Hansen and Associates, Inc.
Consulting Engineers & Land Surveyors

Re: The Sanctuary Weber County Engineering Review Comments

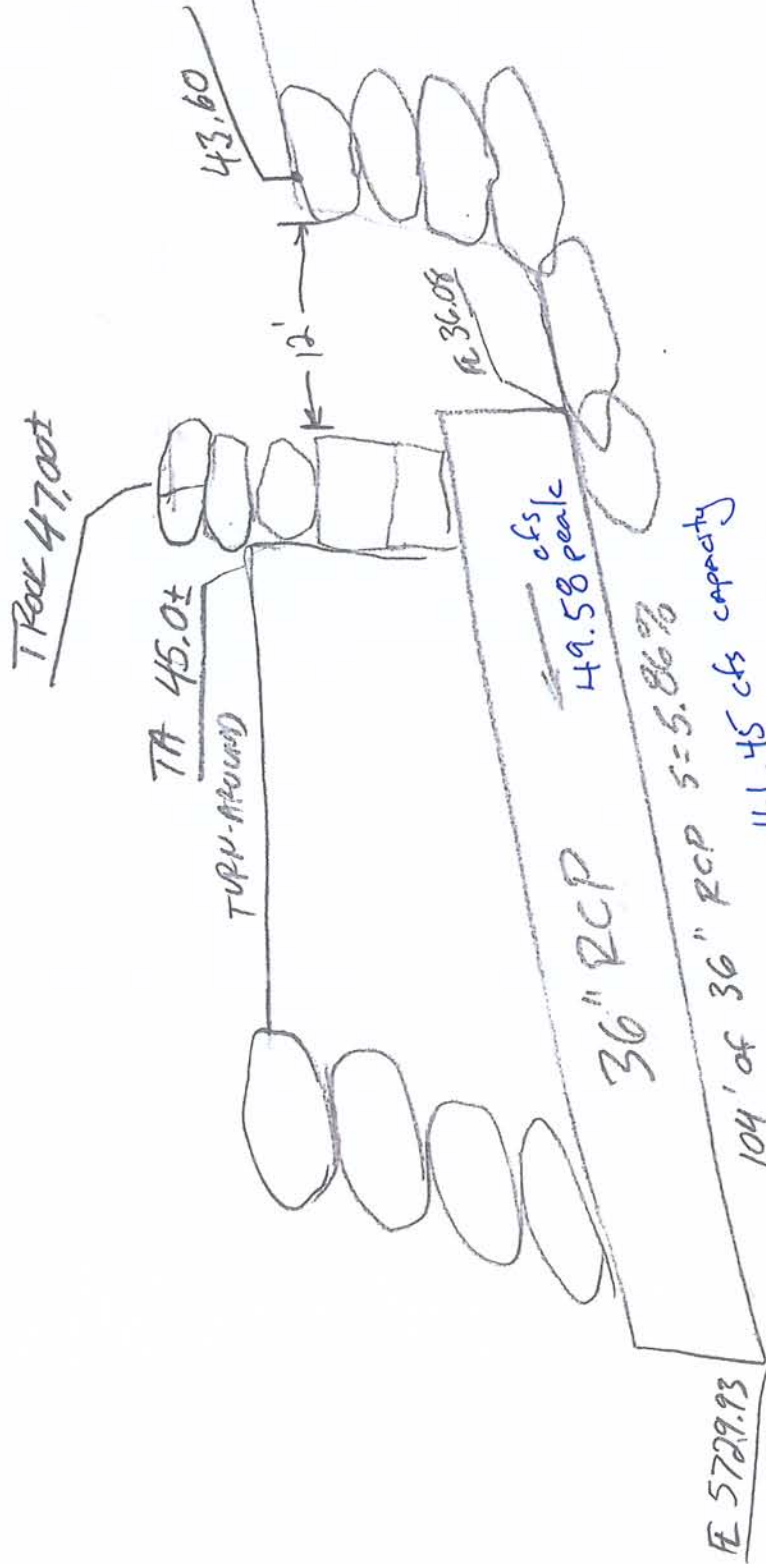
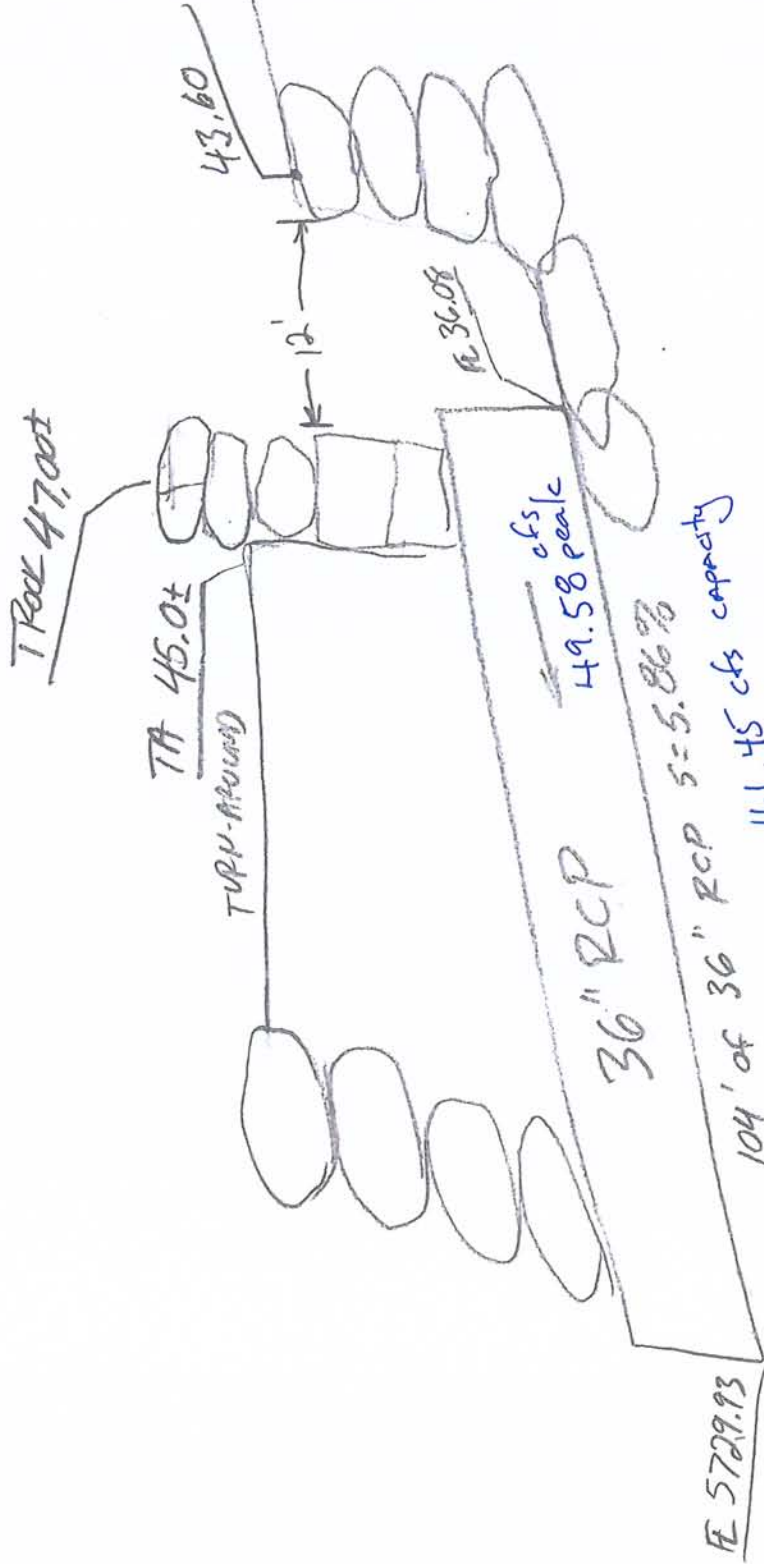
On the 36" pipe, Matt, in his response to you stated that the slope of the 36" pipe was 5.86% and has a modeled capacity of 161 CFS where a peak flow of 50 CFS is required. (Attached find Matt's sketch of the pipe and the calculation printout).

peak discharge = 49.34 cfs (see included section of stormwater calcs)
